Permit Type	Permit Number	Opened Date
Building/Residential/Misc/Porch	B26000600	02/28/2026

Description of Work  
sfd / construct 20x15 screened porch 14x19 open deck landing & steps

**APPLICATION FOR WAIVER**

SITE INSPECTION SHEET

LOCATION DIAGRAM

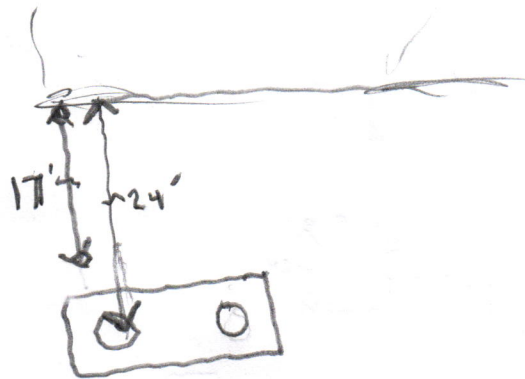
COMMENTS: No observed issues w/ the well & septic  
Proposed 14' x 19' deck will have a 2' cantilever.  
The deck post will maintain a 5' setback to  
septic tank

WALL CHECK DRAWING  
 13044 HIGHLAND ROAD  
 LOT 2  
 MCDANIEL PROPERTY  
 PLAT NO. 23441  
 FIFTH ELECTION DISTRICT  
 HOWARD COUNTY, MARYLAND

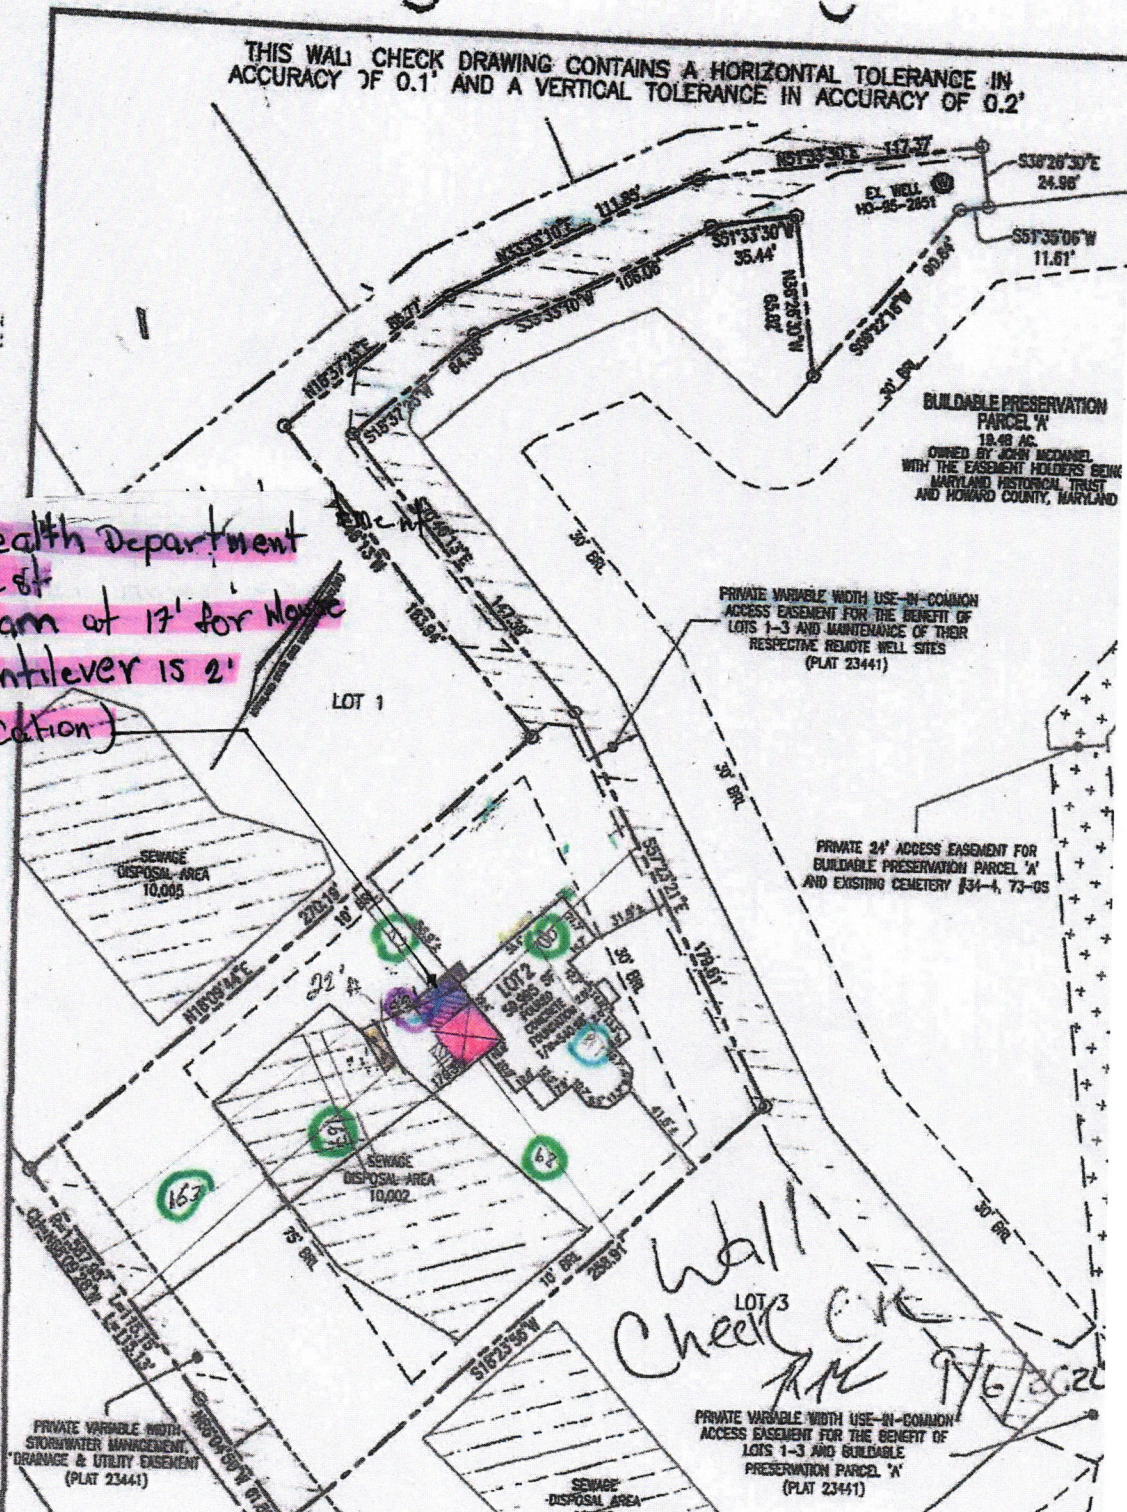
Per Health Department Request  
 Post/beam at 17' for Home Deck Cantilever is 2' (specification)

The updated site plan does not print to scale, so I cannot verify the required 5 foot setback distance to the edge of the existing septic tank. Moreover, you are showing the edge of the septic tank 22 feet off the rear left corner of the house. The as-built drawing shows the septic tank at 19 feet off the corner of the house.

approved for all deck posts to be 5 feet or more from edge of septic tank and deck overhang to be at least 2 feet from edge of tank

Ho-95-2651  
1" : 50'

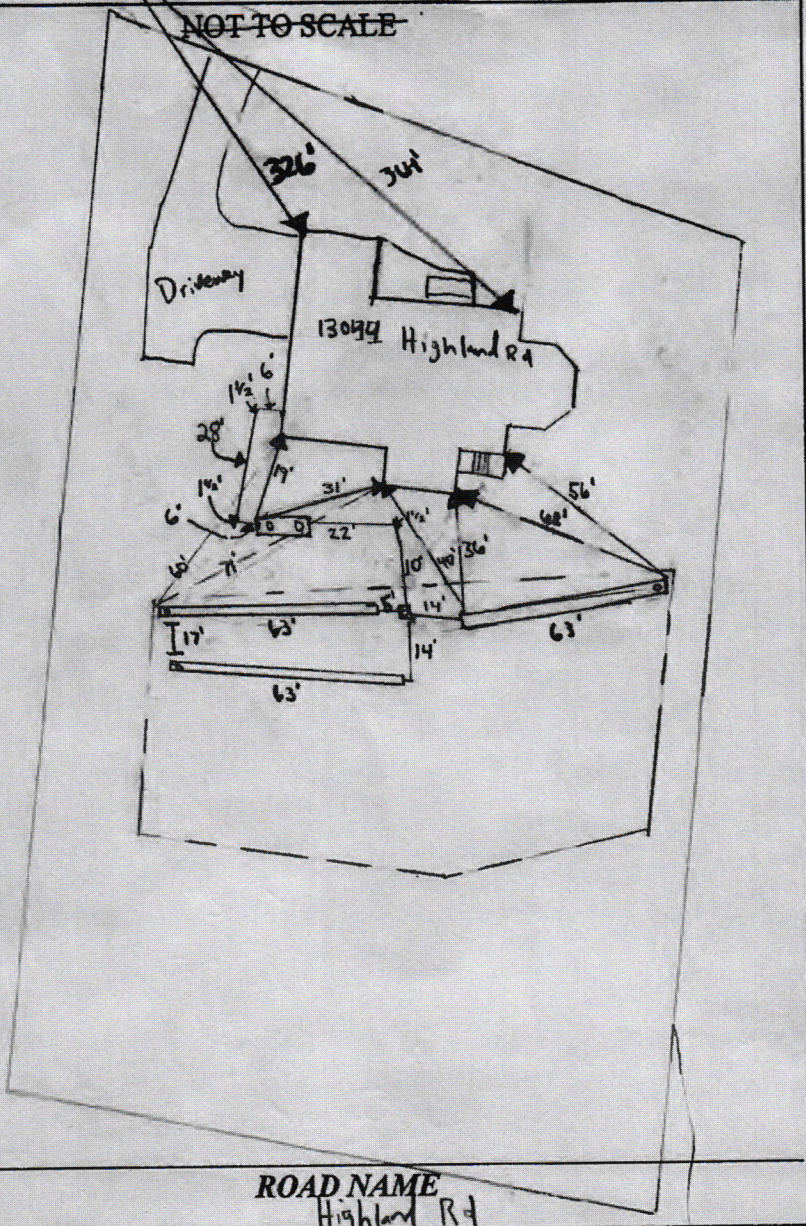
PRE-CONSTRUCTION NOTES:  
10/3/2024 - installers onsite. Sewer not stubbed out of house, septic contractor to drill through wall. Tank started to move 1' away from house compared to plan. Silt started, trenches started. trench lengths @ 63', on contract to distance between trenches 17' + 14'. OK to start.
